**DEPARTMENT OF TRANSPORTATION  
STATE OF GEORGIA**

**FILE:** EDS-84(26), HPPN-EDS-84(27) & NHN-007-03(28) **OFFICE:** Eng. Services  
Ware County  
P.I. Nos.: 522770, 522780 & 522775  
S.R. 38/U.S. 84 Widening/Reconstruction and Bridge Replacement

**SUBJECT: IMPLEMENTATION OF VALUE ENGINEERING STUDY ALTERNATIVES**

# VALUE ENGINEERING STUDY REPORT RESPONSES

# Comment A-7 Layout

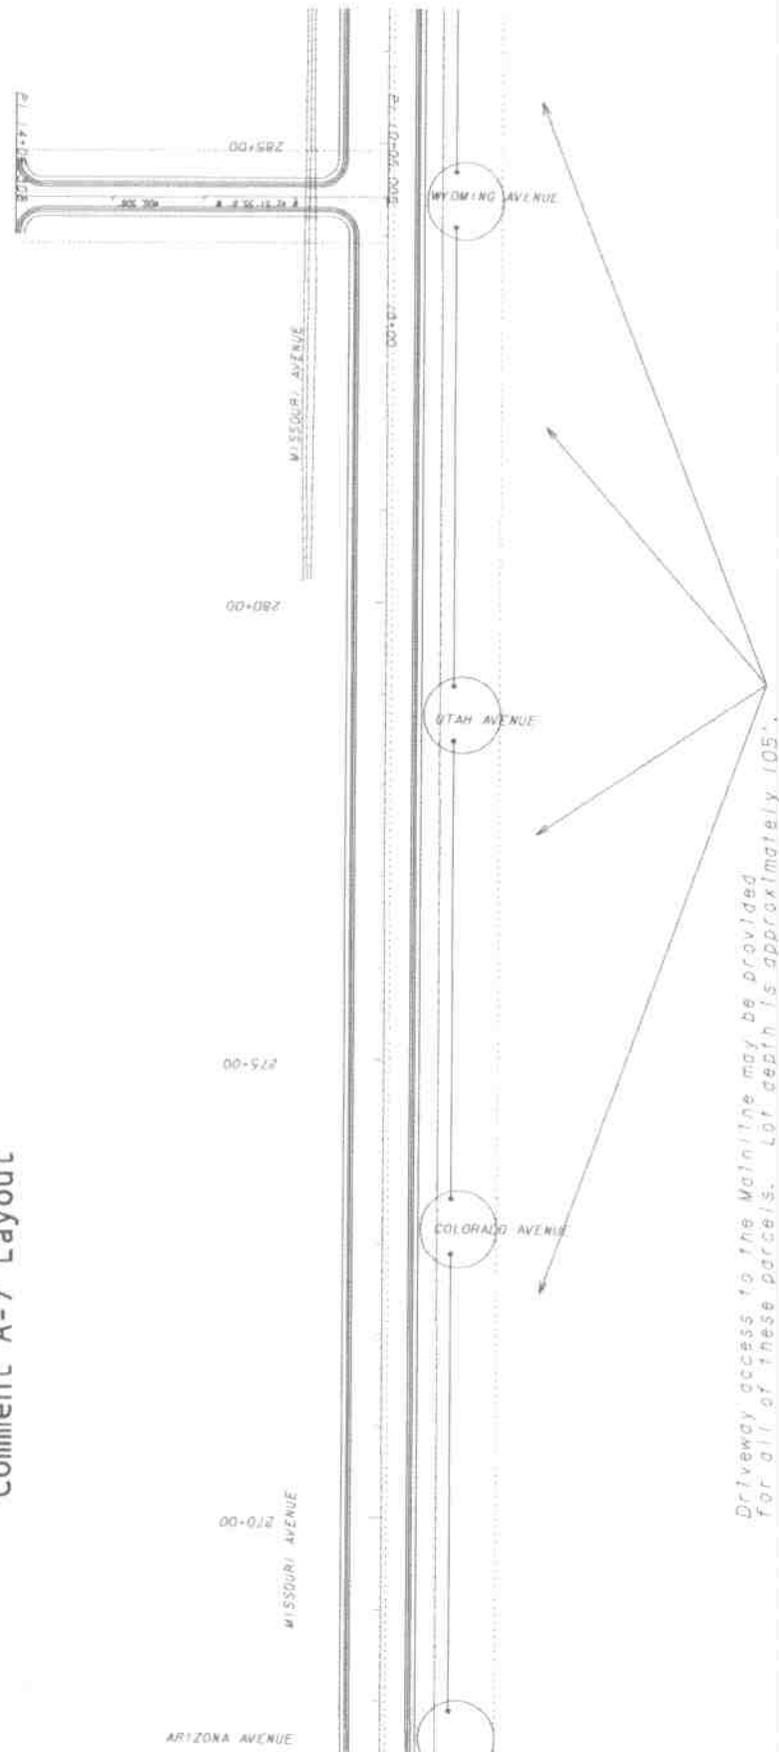
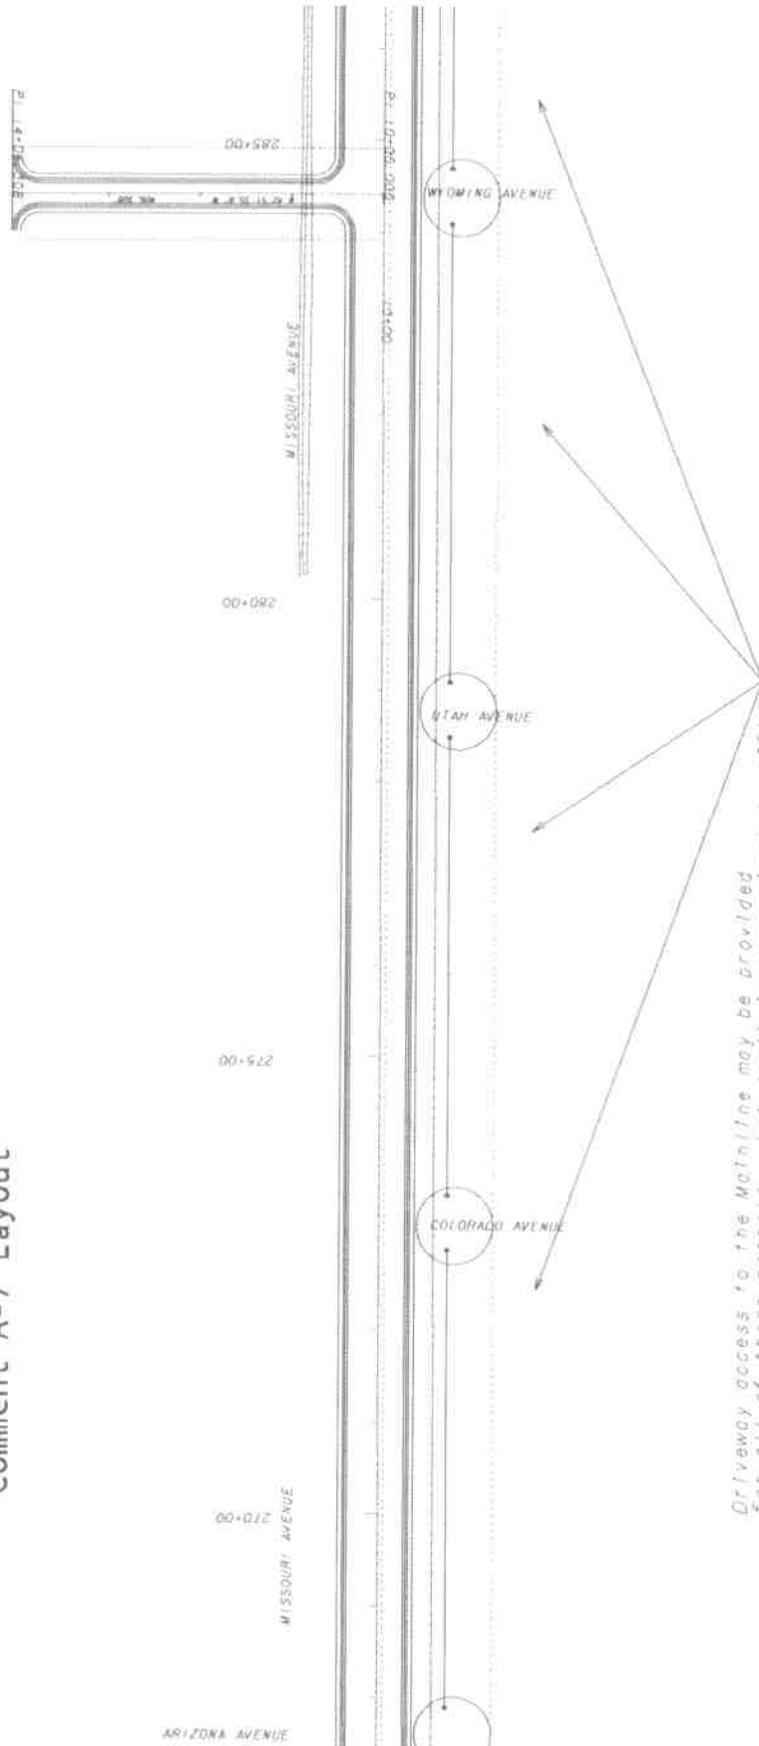
- A-7 Revisit new location alignment through Emerson Park (4F?) 2  
 Right-of-way New Mexico Avenue to Idaho Avenue (new alignment along railroad)  
**This comment incorrectly identifies the parcels to the south of the alignment as landlocked. These parcels will not be landlocked and are capable of being developed as valuable frontage commercial property with possible railway access. Also, the VE team failed to recognize the additional cost of extending the alignment approximately 400'. Nor did the team recognize the required cost of extending the two side roads to meet their proposed alignment. The additional cost for the lengthened alignment would be approximately \$182,300. Also, the team did not recognize the additional cost of required right of way which we estimate to be \$101,600. To implement this comment, the net increase in cost would be approximately \$283,900. (See A-7 attachments)**
